UNITED STATES  
DEPARTMENT OF THE INTERIOR  
BUREAU OF LAND MANAGEMENTFORM APPROVED  
OMB NO. 1004-0135  
Expires: July 31, 2010**SUNDRY NOTICES AND REPORTS ON WELLS**  
**Do not use this form for proposals to drill or to re-enter an abandoned well. Use form 3160-3 (APD) for such proposals.**5. Lease Serial No.  
NMLC031620A

☒ Oil Well ☐ Gas Well ☐ Other8. Well Name and No.  
SEMU 128

30-025-34313-00-S4

**SEMU-128**  
**Procedure to P&A**  
**API#30-025-34313**

# Proposed Rod and Tubing Configuration SEMU 128

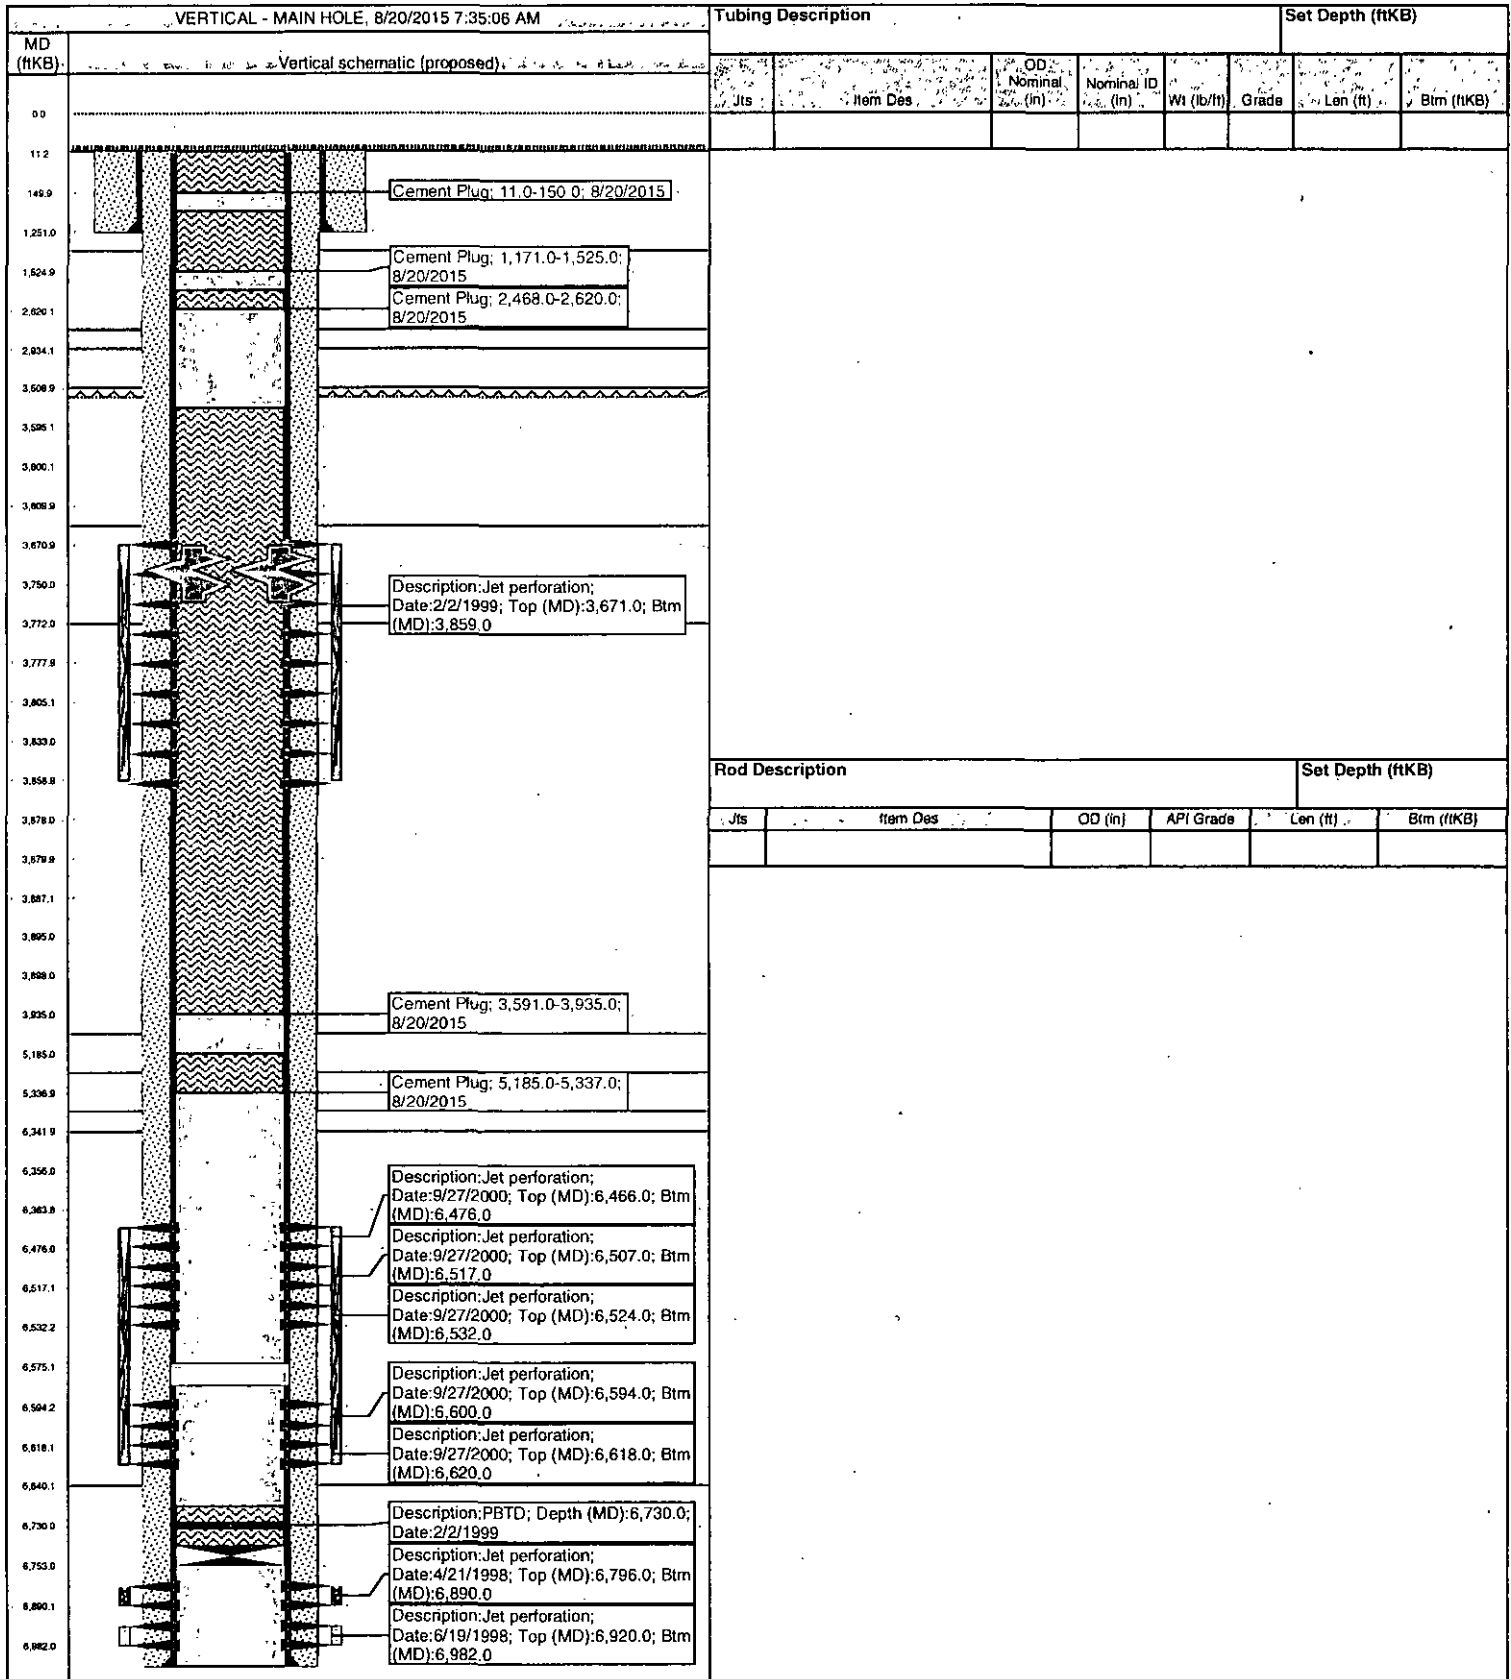
*RIH to PBD spot  
Cmt across Tubb Perb  
from 6670 - 6300. woc  
Tag.*

*9/29/15  
J. Ames*
